## **MYERS HOMEPLACE SUBDIVISION**

APPLICATION NUMBER 19 DATE August 16, 2007

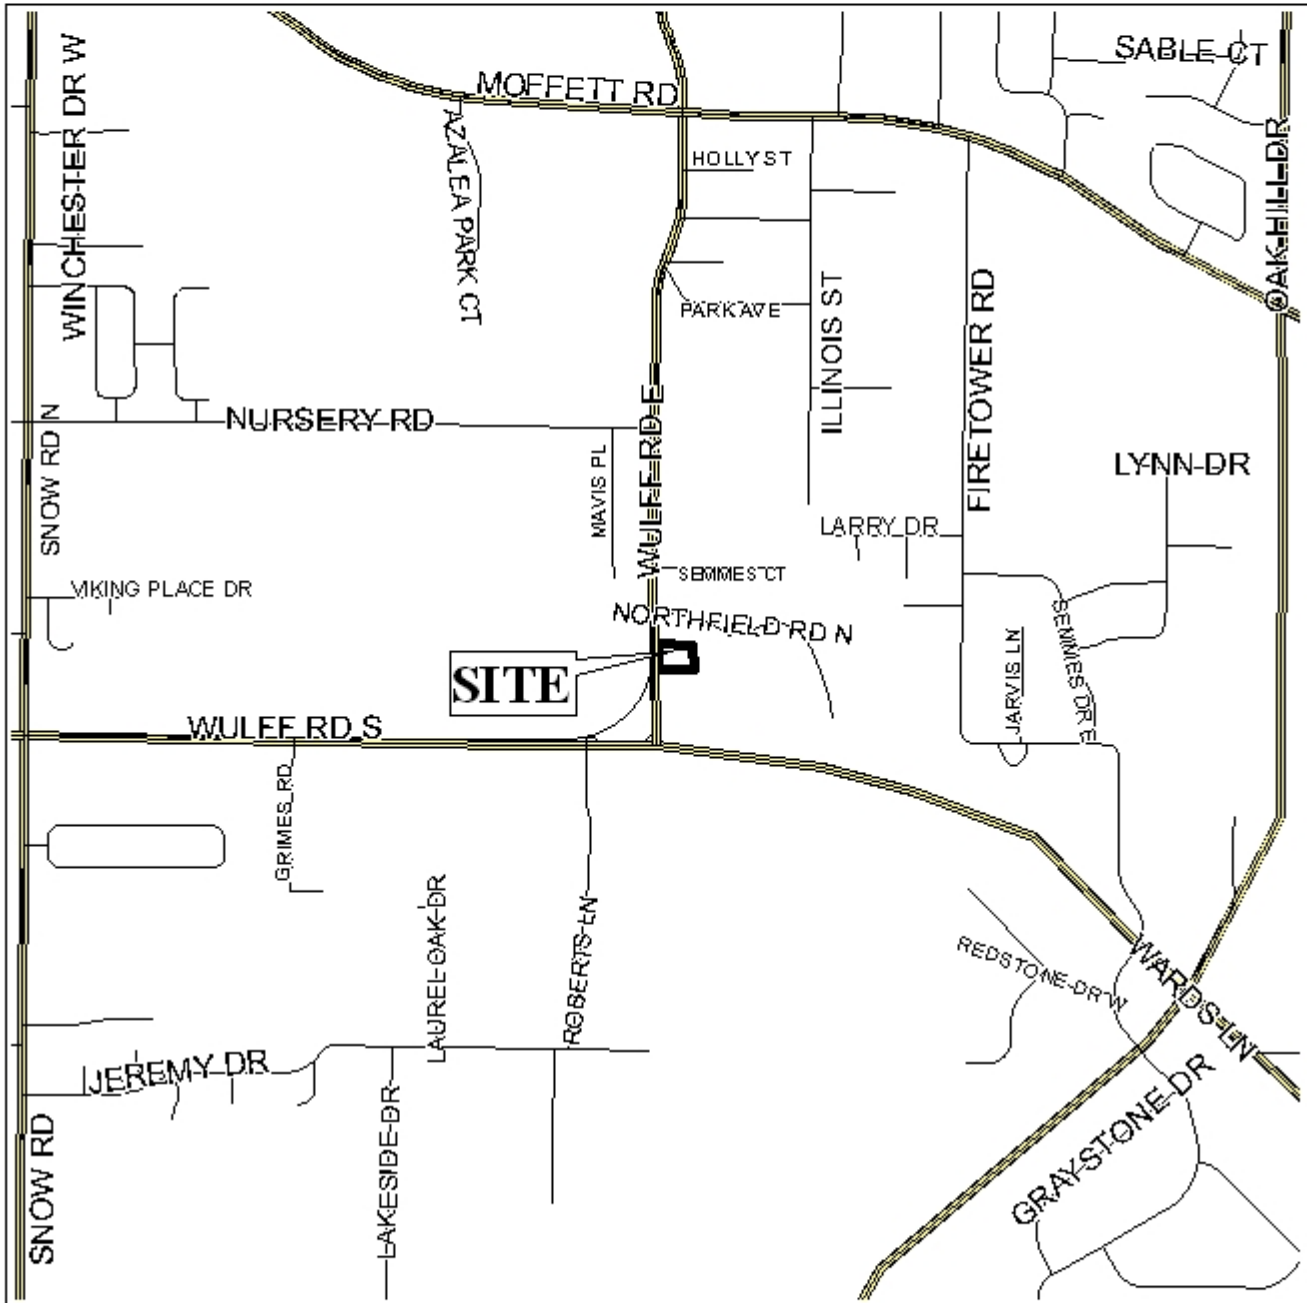
The site fronts Wulff Road, a proposed major street with an existing right-of-way of 80-feet. As a proposed major street, the minimum right-of-way width should be 100-feet, as recommended by the Major Street component of the Comprehensive Plan. The plat should be revised to depict dedication sufficient to provide 50-feet of right-of-way, as measured from the centerline.

Since Wulff Road is a proposed major street, access management is a concern. Each lot should be limited to one curb-cut each, with the size, design and location of all curb-cuts to be approved by Mobile County Engineering.

The 25-foot minimum building setback line, required in Section V.D.9., is not shown for the subdivision, but would be required on the final plat, if approved. The setback line should reflect the required dedication.

While the site is in Mobile County, it will have to comply with the City of Mobile storm water and flood control ordinances. A note should be placed on the final plat stating that the development will be designed to comply with the storm water detention and drainage facility requirements of the City of Mobile storm water and flood control ordinances, and requiring submission of certification from a licensed engineer certifying that the design complies with the storm water detention and drainage facility requirements of the City of Mobile storm water and flood control ordinances prior to the issuance of any permits. Certification is to be submitted to the Planning Section of Urban Development and County Engineering.

A note should be placed on the Final Plat stating that any lots which are developed commercially and adjoin residentially developed property must provide a buffer, in compliance with Section V.A.7. of the Subdivision Regulations.

- 1) dedication of right-of-way sufficient to provide a minimum of 50-feet, as measured from the centerline of Wulff Road;
- 2) placement of a note on the final plat stating that each lot is limited to one curb-cut each, with the size, design and location of all curb-cuts to be approved by Mobile County Engineering;

- 3) depiction of the 25-foot minimum building setback line;
- 4) revision of the plat to label each lot with its size in square feet, or placement of a table on the plat with the same information;

- 5) placement of a note on the plat stating that the development will be designed to comply with the storm water detention and drainage facility requirements of the City of Mobile storm water and flood control ordinances, and requiring submission of certification from a licensed engineer certifying that the design complies with the storm water detention and drainage facility requirements of the City of Mobile storm water and flood control ordinances prior to the issuance of any permits. Certification is to be submitted to the Planning Section of Urban Development and County Engineering.; and

- 6) placement of a note on the final plat stating that any lots which are developed commercially and adjoin residentially developed property must provide a buffer, in compliance with Section V.A.7. of the Subdivision Regulations.
